MODEL :		REV :	CHANGE LIST :	MODEL : Z01 MB			
		1A	FIRST RELEASE	PAGE	FROM	TO	
Z01 MotherBoard	1B	PAGE02. 1. R447,455,456 MODIFY to EP P/N:CS14752FB11 PAGE03. 1. STUFF HOLE6 P/N:FBZ01007010 2. STUFF HOLE7,8,15 P/N:FBED8001016 , 3. STUFF HOLE5 P/N:FBZ01006010 PAGE03. 1. STUFF HOLE23,25 P/N:FBZ01003010 2. STUFF HOLE18 P/N:FBZ01004010 , 3. STUFF HOLE31 P/N:FBZ01005010 PAGE05. 1. U22 MODIFY to GM965 P/N:AJ00QNI20T04 , 2. R193,194 MODIFY to EP P/N:CS03902FB11 PAGE06. 1. R242 MODIFY to EP P/N:CS33002JB23 PAGE08. 1. L52,53 MODIFY to EP P/N:CV01004KKN00 PAGE11. 1. R332 MODIFY to EP P/N:CS23243F930 , 2. U6 MODIFY to ICH8 P/N:AJ00QM740T03 PAGE12. 1. R244,R347,R353 MODIFY to EP P/N:CS00004JA40 , 2. L28 MODIFY to P/N:CV-1005MZ01 PAGE13. 1. CN10 MODIFY to CRT P/N:DFDS15FR611 PAGE15. 1. R467 MODIFY to EP P/N:CS00004JA40,2. R50 MODIFY to EP P/N:CS31003J941,3.CN27 MODIFY to SATA P/N:DFHS22FR005 PAGE16. 1. CN16 MODIFY to RJ45/11 P/N:DFTJ15FR057 PAGE18. 1. R317,323 MODIFY to 0603 P/N:CS31003F949 , 2. R310 MODIFY to EP P/N:CS31003J941 PAGE20. 1. PR100 MODIFY to EP P/N:CS51002FB11 PAGE21. 1. PR86 MODIFY to EP P/N:CS24022FB13 , 2. PR38,82 MODIFY to 1% P/N:CS31002FB26 , 3. PR83 MODIFY to EP P/N:CS00004

Size	Document Number CLOCK GENERATOR CK505 W/REGULATOR	Rev 2B
Date:	Thursday, May 17, 2007	Sheet 3 of 26

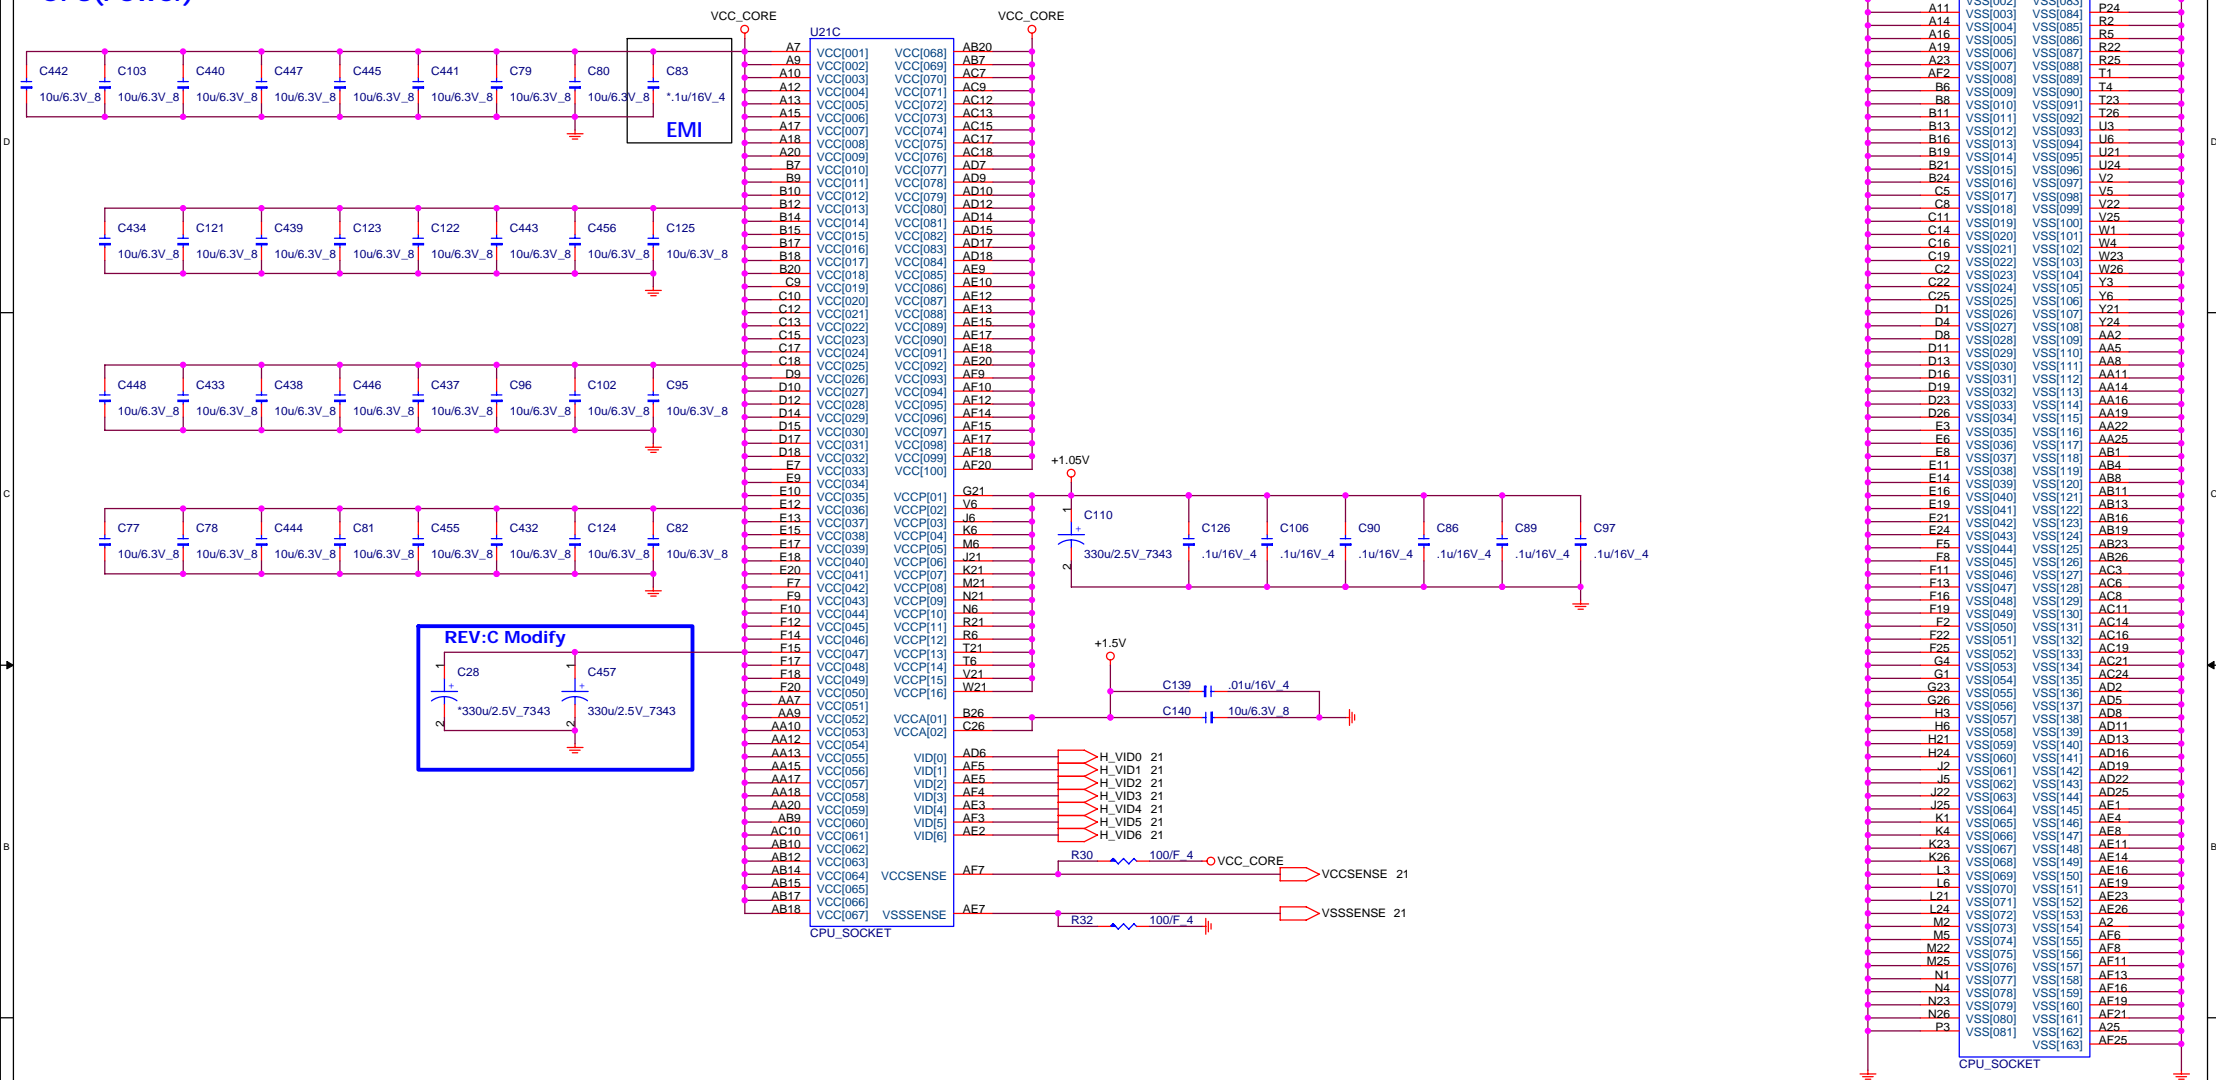
2	2B			
			3	2B			
			4	2B			
			5	2B			
			6	2B			
			7	2B			
			8	2B			
			9	2A			
	2A	PAGE02. 1. Connect VDDIO_CLK to +1.25V 2. un-stuff R292;R445;R308 3. stuff C575,C574,C576,C578,C573,C546 for EMI issue PAGE06. 1. Connect ICH_PWROK SIGNAL TO NB CLPWROK 2.un-stuff R242;R235;R422;R222;R421;R423 3. R360,R361 only stuff for UMA PAGE07. 1. MODIFY 22u to 10u PAGE08. 1. R489 MODIFY to 0805 2. Stuff L50;R182;C238 for EV@ (MXM) PAGE09. 1. Add PU for SMA MA14 ; SMB MA14 PAGE10. 1. un-stuff R337,C115,C127,C129,C298,C302,C294,C283,C291 PAGE11. 1. Q18 MODIFY to P/N:AL07SZ04C27 2.R395 connect to VCCRTC 3.R336;R251;R419;R255 un-stuff 4.R226 connect to +3V S5 5.ICH_PWROK to SB CLPWROK PAGE11. 1. stuff C500,C509,C300,C513 33pF P/N:CH03306JB04 2. C507,C508 10pF change to 15pF P/N:CH01506JB06 , 3. stuff R238,R392,C2989 for Contr-LINK1 PAGE12. 1. VCHDA & VCCSUSHDA change to 3V PAGE13. 1. ADD CRT DDC IN PU , 2. L8,L9,L10 P/N change to 0.47UH for MXM , 3. C22,C24,C25,C27,C31,C32 P/N change to 47pF for MXM PAGE14. 1. CN6 MODIFY CONN. to 5 PIN P/N:DFHD05MRD98 PAGE15. 1. MODIFY SWITCH BOARD PIN DEFINE 2. Modify FAN circuit , 2. MR1 P/N change to AL000268000 PAGE16. 1. C46,C47 27pF change to 33pF P/N:CH03306JB04 2. stuff C104,C105,C119,C112 0.1uF P/N:CH41003ZB35 PAGE17. 1. CARD READER COLAY TO CN28, DEL CN30 2. C311 change to 27pF P/N:CH02706JB06 3. stuff R209 4. un-stff R213,C325,U11 PAGE18. 1. CHANGE MDC & CODEC to 3V 2.Delete D12 3. stuff R314,R483,C393,C595 PAGE19. 1. SWAP NBSWON# & ACIN 2. C363,C364 5.6pF change to 18pF P/N:CH01806JB07 PAGE20. 1. Modify PQ19 P/N PAGE21. 1. Modify Capacitor P/N to meet ME height limit PAGE22. 1. stuff PR74,PC69 2. Remove JP Pad PAGE23. 1. stuff PR126,PC131,PC137 2. Remove JP Pad 3. un-stuff +1.8V PAGE25. 1. un-stuff PR101,PQ21,PR22,PQ2,PR26,PR9,PR5,PC33,PC38,PC39,PC19,PC22,PU2			10	3A	3B

Size	Document Number	Rev
	CHARGER (ISL6251A)	3A
Date:	Thursday, May 17, 2007	Sheet 25 of 26

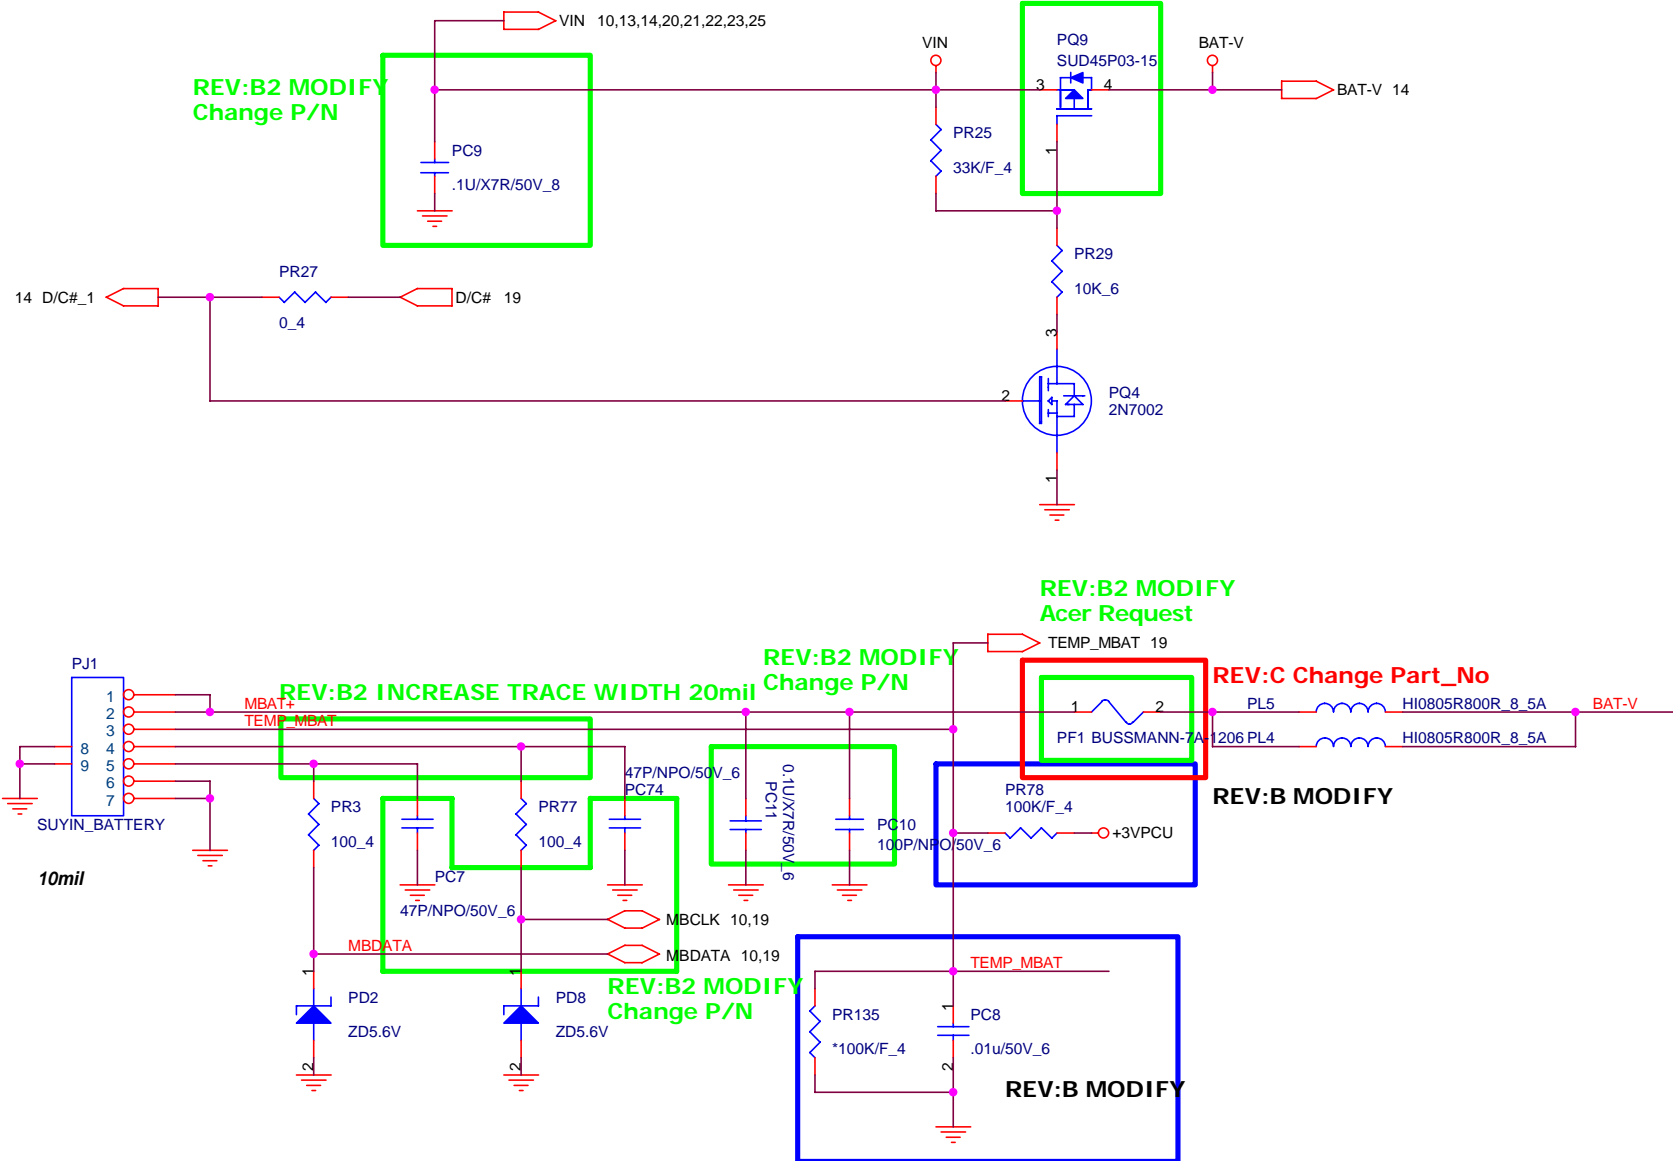
23	3A	3B			
		24	3A				
		25	3A	3B			
3A	PAGE10. 1. Add +2.5V & +1.8V capacitors for nVIDIA MXM card PAGE11. 1. Change C507,C508 to 15pF for RTC PAGE13. 1. Add C609 & C610 to meet CM2009 specification PAGE14. 1. Reserve +5VPCU & Add Q40,R540 for CIR PAGE15. 1. Add C611 for PLC hall IC 2. Stuff R60 for G995 PAGE19. 1. CN24 un-stuff 2. D322,D332 reserve for ESD PAGE21. 1. Modify PC85 value PAGE22. 1. Modify PR4,PC13 value for sequence PAGE23. 1. Add PQ22 for nVIDIA MXM +1.8V PAGE24. 1. Modify PF1 P/N PAGE25. 1. Add PU2 for nVIDIA MXM +2.5V						
3B	PAGE10. 1. Remove R337 & Add R542,Q41,Q42 for Nvidia ACIN function PAGE13. 1. Add D34-D36,D40 for ESD solution PAGE15. 1. R484,R485,R486 from 330 change to 220 ohm for LED light issue 2. Add D41,D42,D43 for ESD 3. Stuff Q39 PAGE16. 1. Add C621,C622 for EMI solution 2. C112,C119 change to 100pF/50V for EMI PAGE18. 1. Un-Stuff L55, Stuff U16,R470,R471 for internal Mic. issue PAGE19. 1. Modify D32,D33 package to 0402 for ESD PAGE23. 1. Add PR140,PR141 for +1.8V voltage PAGE25. 1. Stuff PR22,PR101,PQ2,PQ21 for nVIDIA MXM +1.8V & +2.5V Discharge
